PRODUCT CHANGE NOTIFICATION

Date: May 3, 2021
PCN: PCN LEDIL 171

Subject: PCN 171 - Correction of product mechanical drawing

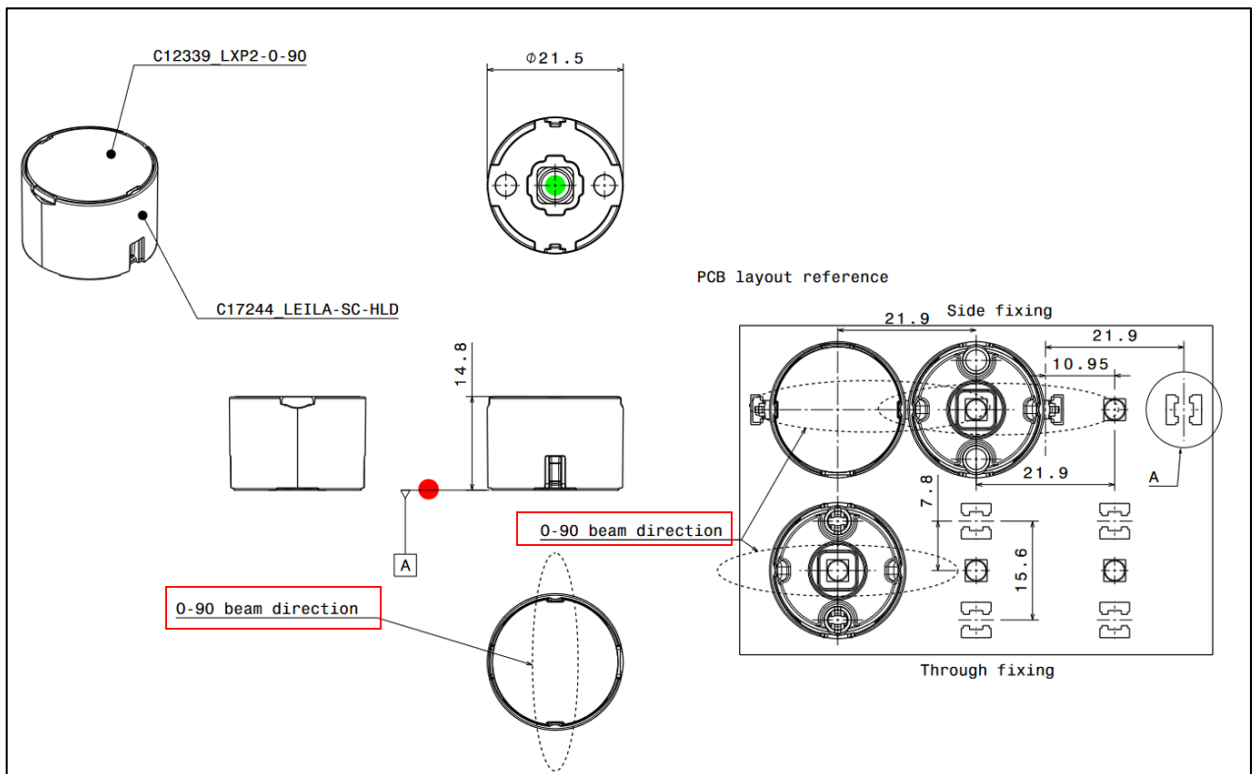
Description: As part of our continuous improvement process regarding the quality of our products, LEDiL has corrected incorrect information on the mechanical drawing of CP17590_LEILA-SC-O-90. Light distribution orientation indicator mark has now been updated in the right direction.

Changes: CP17590_LEILA-SC-O-90 mechanical drawing update.
Updated light distribution direction mark orientation.
